11 September 2020

SECTION 4.55(2) MODIFICATION APPLICATION
Building R4B, One Sydney Harbour, Barangaroo South Sydney

Figure 1 Proposed residential changes on the low-rise and mid-rise plates.

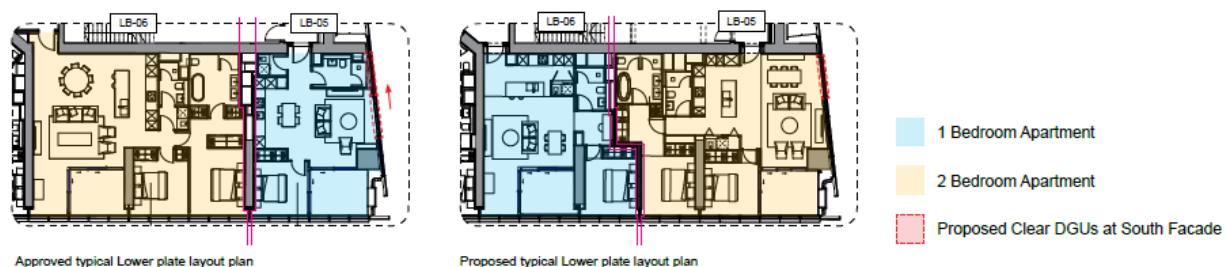
Firstly, it is proposed that west facing apartments LB-05 and LB-06 on the low-rise and mid-rise floor plates are to be repositioned, placing the two bedroom apartments on the corner, providing dual aspect, and the one bedroom apartments shifting north on the plate, allowing for an increase in primary façade frontage and increased internal area (refer to **Figure 1**). To respond to this change, it is also proposed that some minor façade changes are made, including shifting the operable window eastwards.

Figure 4 Proposed changes to the sky home levels

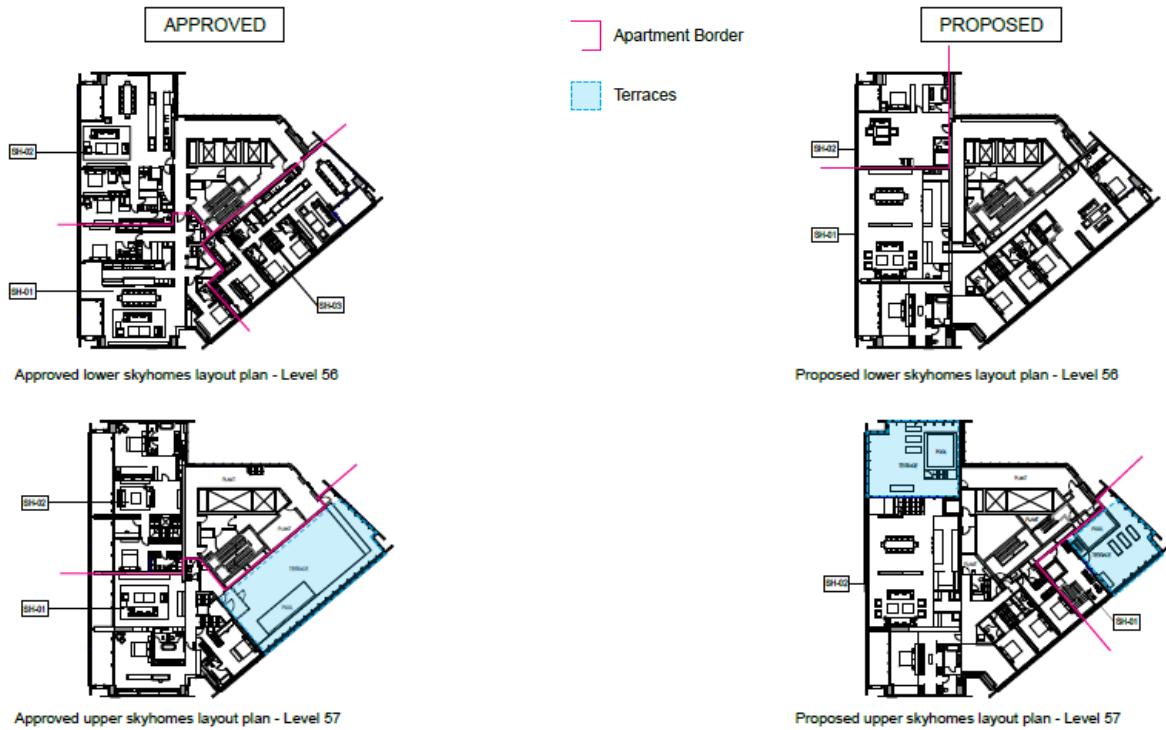
The sky homes at the top of the building are also proposed to be reconfigured due to design development and in response to recent market feedback. The number of apartments will reduce from three apartments to two apartments across both floors. Subsequent amendments are also proposed to the roof terraces at the top of the building. The proposed changes involve internal reconfigurations and split roof top terraces, as illustrated in **Figure 4**.

Figure 6 Proposed façade changes on the upper levels

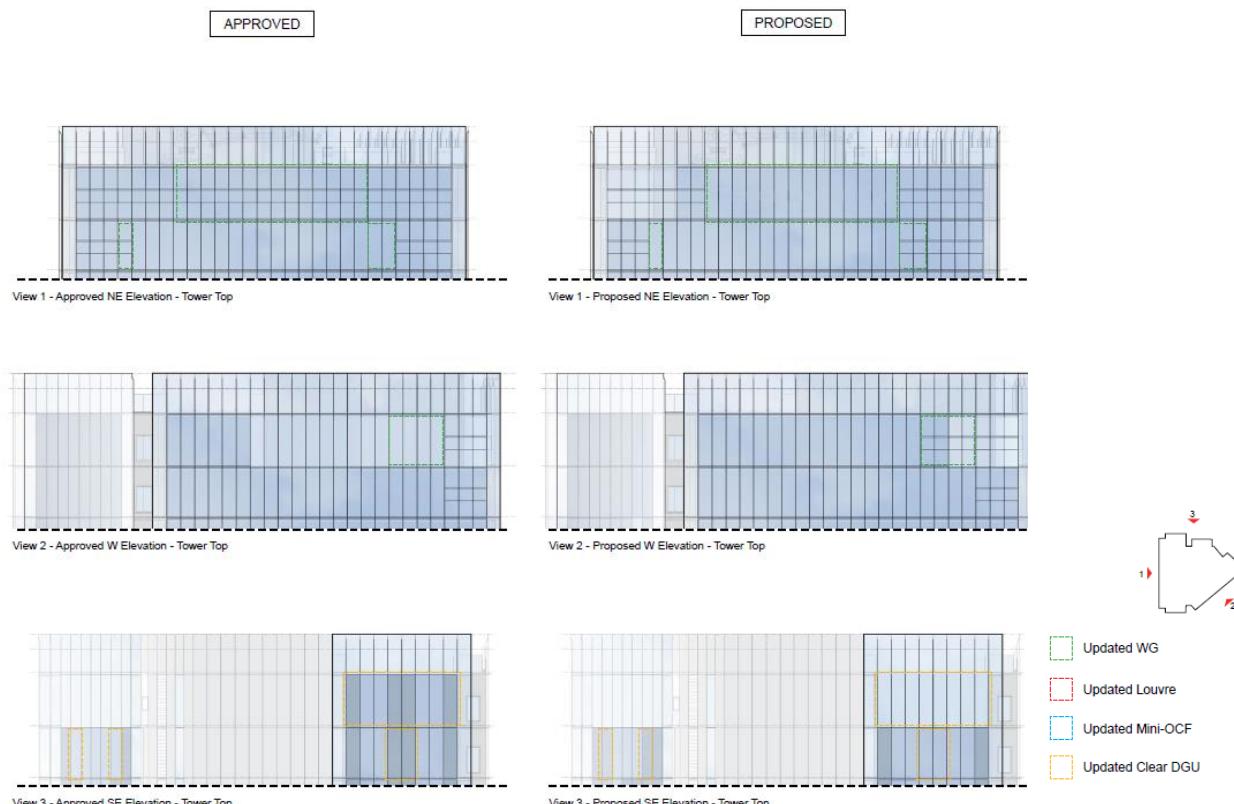
At the sky home levels, the reconfiguration and rationalisation of the terraces has resulted in the need for a reallocation of façade features for the wintergardens. These changes are illustrated in **Figure 6**.

Figure 7 Proposed change to the awning and skirt of the residential lobby façade

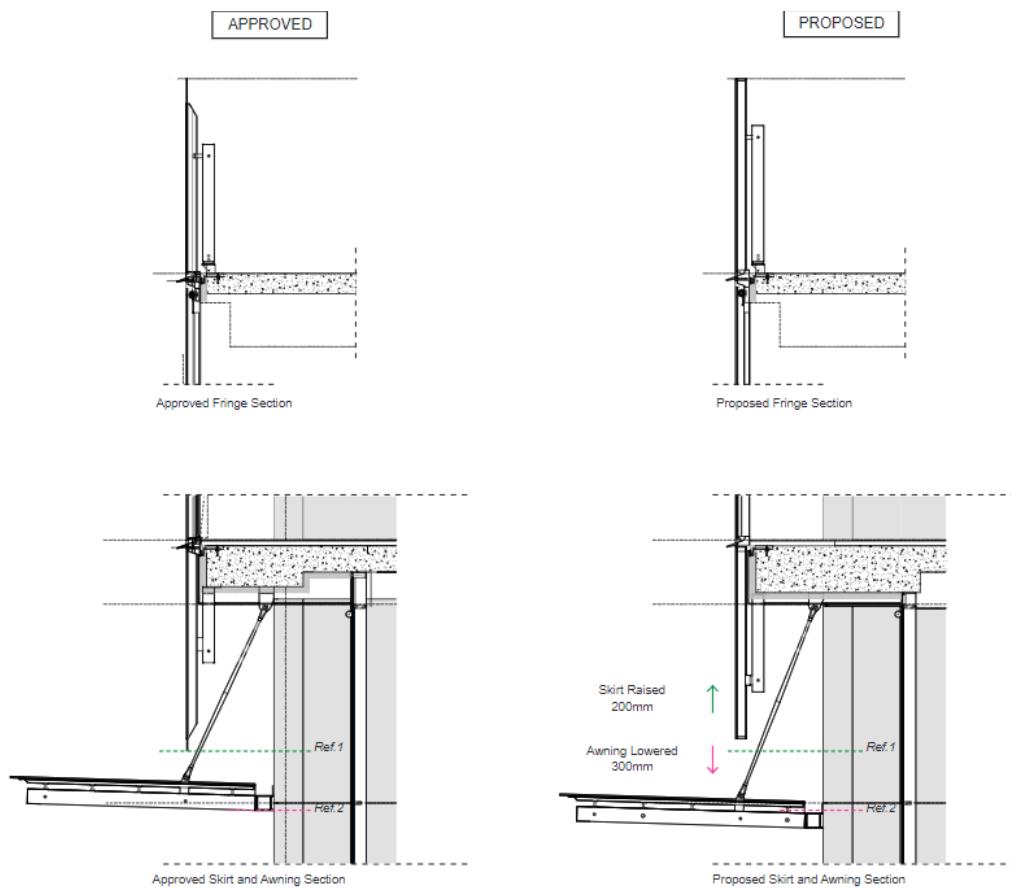
A minor amendment is also proposed to the lowermost façade panels of the residential lobby and uppermost façade panels of the fringe located at the top of the building. A cap is proposed for both panels to create a consistent visual framing of the building so the skirt, fringes and wings share similar appearances at its edge and to better respond to both structure and durability concerns. This amendment is consistent with the change proposed for Building R4A and will therefore ensure consistency across the One Sydney Harbour buildings. The change is illustrated in **Figure 7**.

As part of design development, detailed analysis of the awning and skirt relationship at the lower levels has also been undertaken. As an outcome of this analysis it has determined that the skirt should be raised by 200mm and the awning lowered by 300mm to avoid conflict. This change, as illustrated in **Figure 7**, is proposed for both the north-east park façade and entry vestibule awnings.

Figure 8 Reconfiguration of the residential lobby water feature

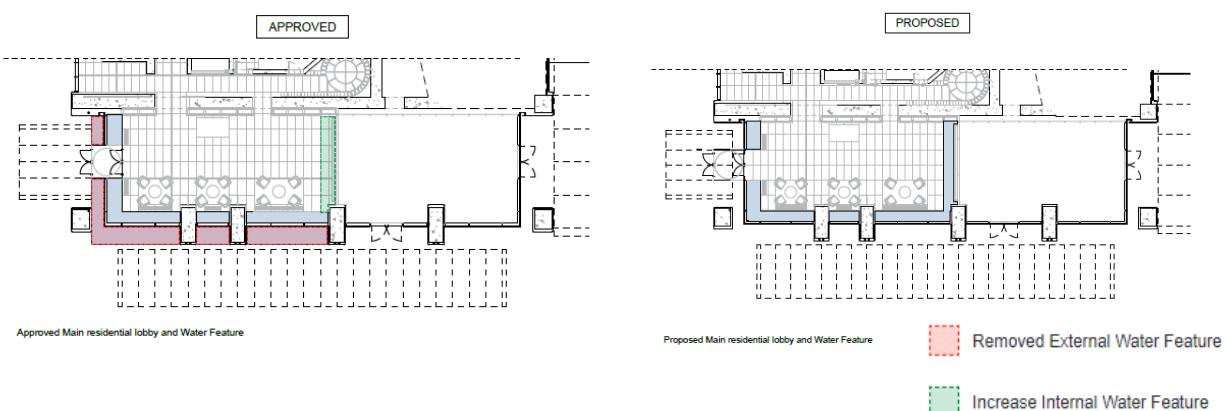
A number of internal and external design modifications are proposed to the residential lobby on the ground level as a result of further design development. The first change relates to the water feature and involves the reconfiguration of the water feature design to be three-sided and contained within the internal space, allowing for better management of external conditions (for example, water spray) by removing the outdoor water elements (refer to **Figure 8**).

Figure 9 The proposed movement of the entry vestibule

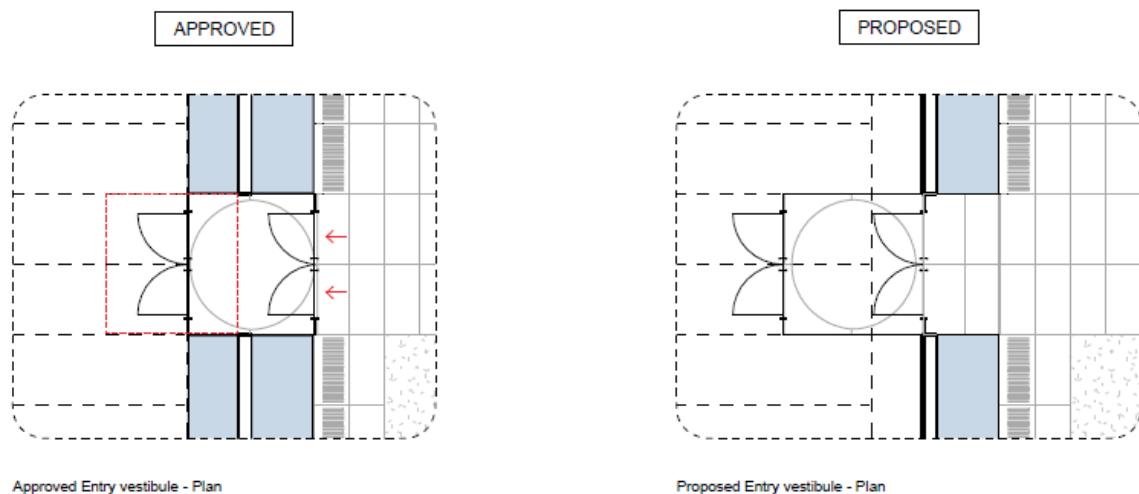
Secondly, the entry vestibule has been revised to better respond to the changes to the water feature. It is proposed that the glass box is shifted approximately 1.2 metres, locating the vestibule outside the perimeter of the water feature (refer to **Figure 9**). This change will result in a slight increase of GFA at the ground floor level.

Figure 10 Reconfiguration of the Lift Core

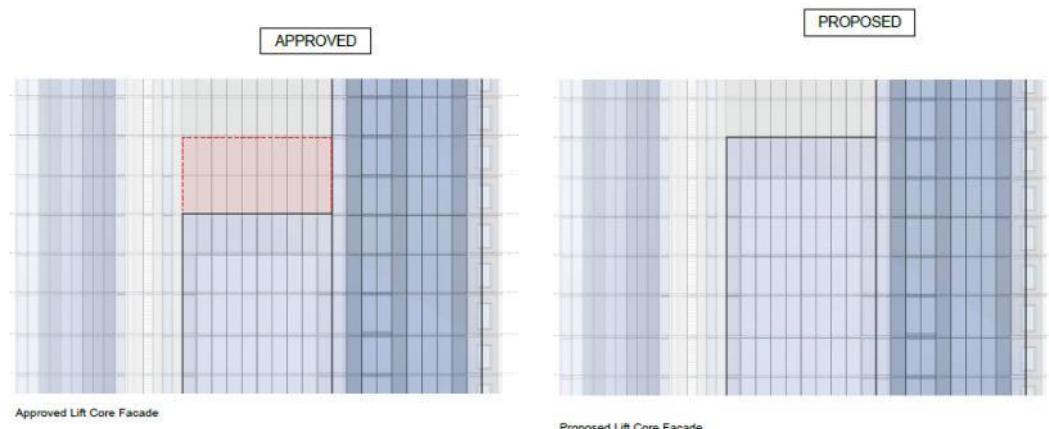
The low-rise lift core is proposed to be raised in height by approximately two levels to align with the uppermost level of the low-rise floor plate. This change is proposed in light of further development on the lift services and detailed considerations regarding the lift motor room and overrun sizes, the lift core volume of the SE façade. The lift core has shifted to contain the lift motor room at Level 35, the lift roof at Level 36 and the uppermost overhanging glass fringe spanning over the roof until Level 37.

As a result of this amendment, the façade panels relating to the lift core will be extended by another two levels (refer to **Figure 10**).
